**CHEVRON PRODUCTS COMPANY'S COMMENTS ON:
PROPOSED STATE IMPLEMENTATION PLAN FOR THE 2015 OZONE NAAQS NORTHERN
WASATCH FRONT MODERATE NONATTAINMENT AREA**

SUBMITTED ELECTRONICALLY TO THE UTAH AIR QUALITY BOARD

JULY 17, 2023

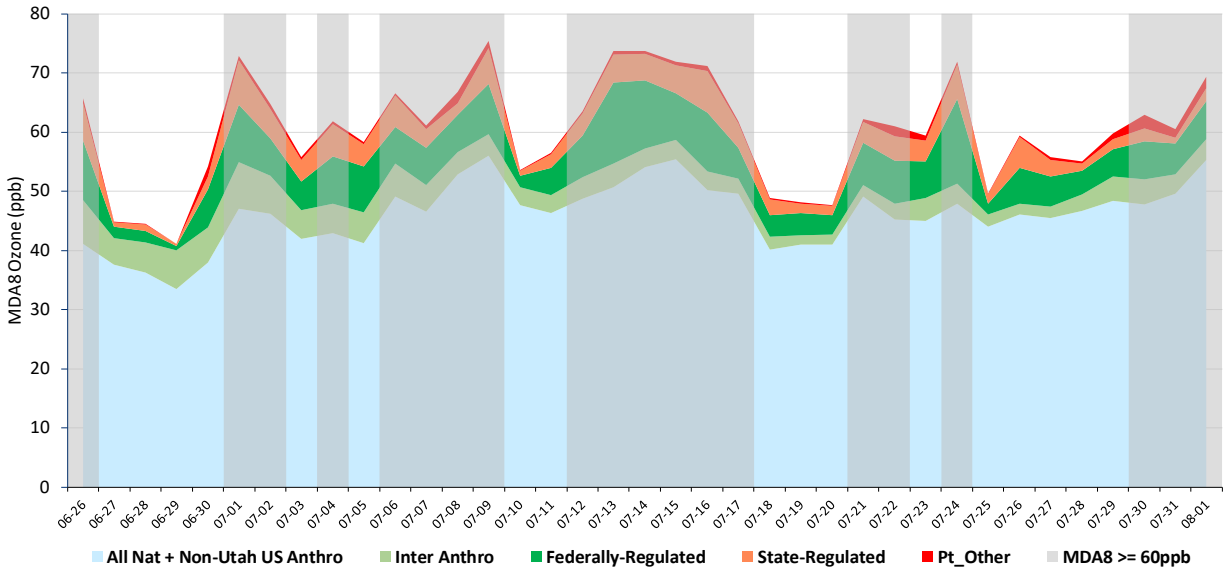
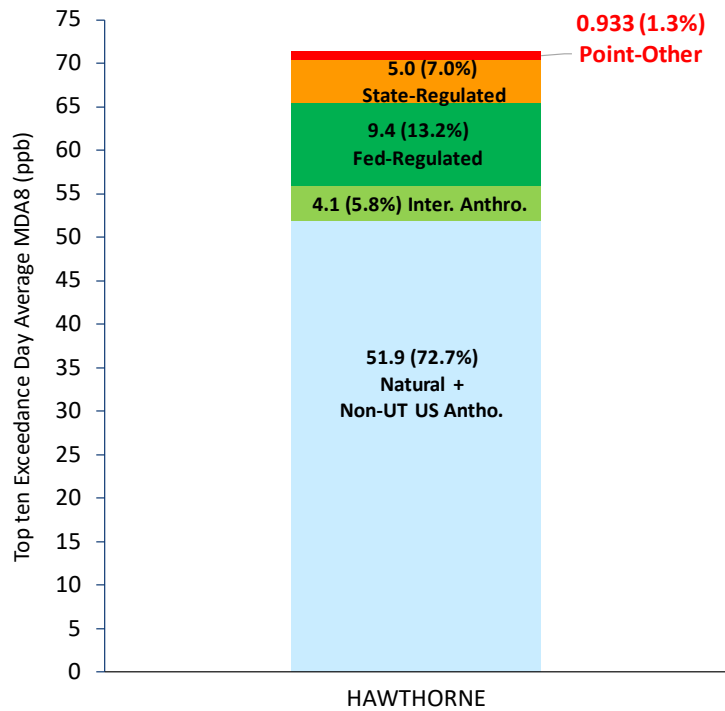
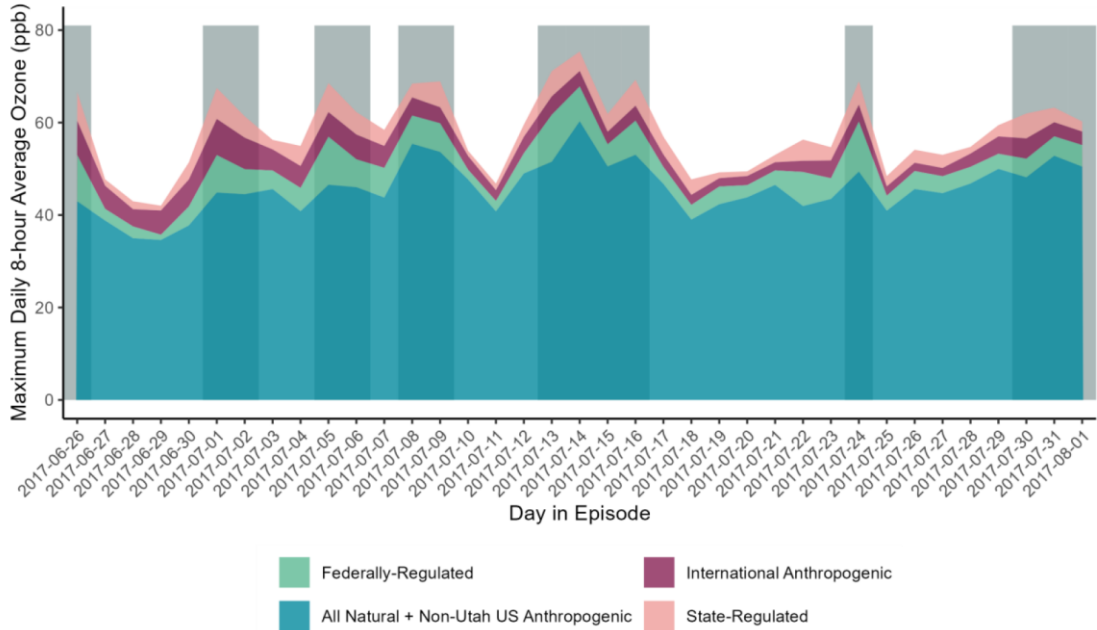
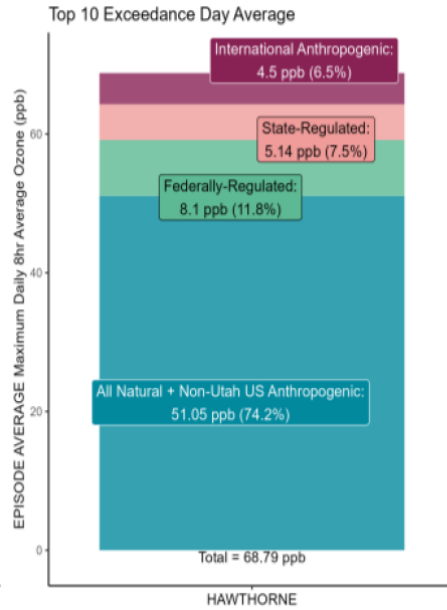
We received UDAQ’s model output files via disk transfer and processed raw hourly OSAT tracer concentrations to MDA8 ozone in local time. Figure 4(a) shows resulting time series of attribution for five aggregate source categories at Hawthorne, while Figure 4(b) shows the average over the top 10 highest simulated ozone days. Figure 5 is a copy of Figure 17, page 132 from the main SIP document. We extracted data from CAMx “receptor files”, which report source apportionment results at pre-defined receptor coordinates defined by UDAQ. However, we could not replicate UDAQ’s source apportionment results; while exhibiting similar patterns, our results tend to be higher during peak periods and the distribution of high days differ.

We conducted substantial quality assurance checks of our approach at each processing step and tested numerous possible causes. This included confirming that we could achieve identical results by extracting data from raw gridded data (rather than receptor files) and confirming that total ozone simulated by the core model at Hawthorne matched the sum of all tracers shown in Figure 4. We also extensively interacted with UDAQ staff to find possible reasons of discrepancies at each step of processing but could not identify a specific cause. Based on our substantial checks, we are certain that our results are correct.

Figure 6. Average of Ramboll’s processing of MDA8 ozone contribution at Hawthorne over the top 10 days shown in Figure 4(a) from 6 aggregated “other point source” tracers. Contributions are split by whether ozone was generated by NOx (O3N) or VOC (O3V) sensitivity photochemistry.

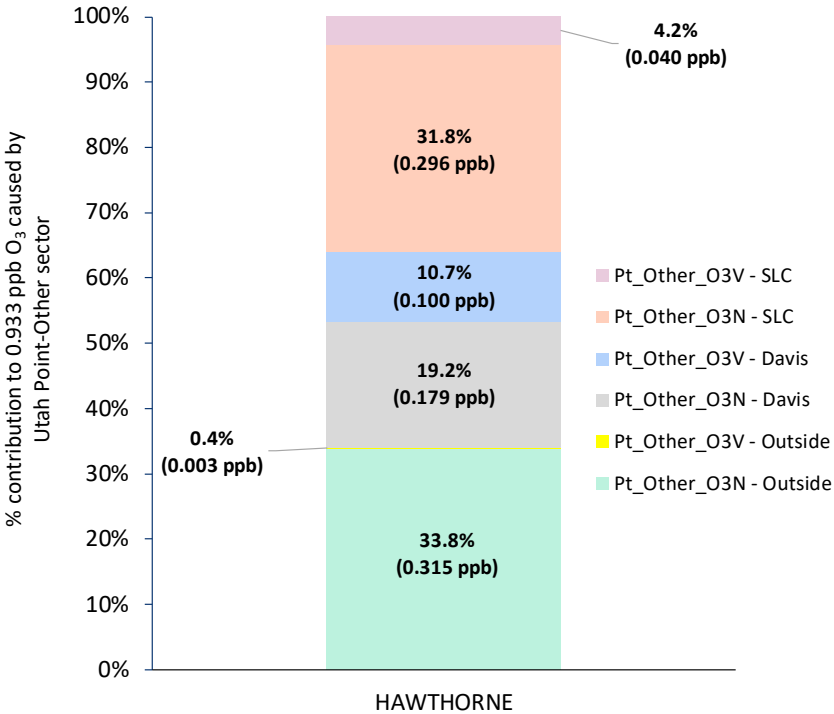
According to our results, the “other point source” category that contains refineries contributes a total of 0.9 ppb over the top 10 simulated MDA8 ozone days. Figure 6 shows a breakout of the 0.9 ppb contribution from “other point sources” by NOx (O3N) and VOC (O3V) sensitive ozone production, and from Salt Lake County, Davis County, and other areas outside the two counties. Point sources in Salt Lake County contribute 0.30 ppb (32%) and 0.04 ppb (4%) from NOx and VOC sensitive chemistry, respectively. Point sources in Davis County contribute 0.18 ppb (19%) and 0.10 ppb (11%) from NOx and VOC sensitive chemistry, respectively. For both counties, results indicate more NOx-sensitive ozone formation from point sources. All other point sources located throughout the remainder of the 4/1.33 km modeling domains contribute 0.32 ppb (34%) and <0.01 ppb (0.4%) from NOx and VOC sensitive chemistry, respectively. The stronger NOx-sensitive response from the outside point sources makes sense as they are mostly removed from the central urbanized area of the NAA, and thus ozone formation occurs in more NOx-lean and relatively biogenic VOC-rich suburban and rural areas.

We estimated the ozone impacts from simulated refinery control measures in 2023 at Hawthorne by multiplying contributions from Figure 6 by the relative emission reductions shown in Table 1. Results are shown in Table 2. The total simulated MDA8 ozone reduction from refinery measures averaged over the highest modeled ozone days is 0.02 ppb. Conceivably this impact would be smaller if the model simulated a VOC-sensitive environment rather than NOx-sensitive, as indicated by monitoring studies.
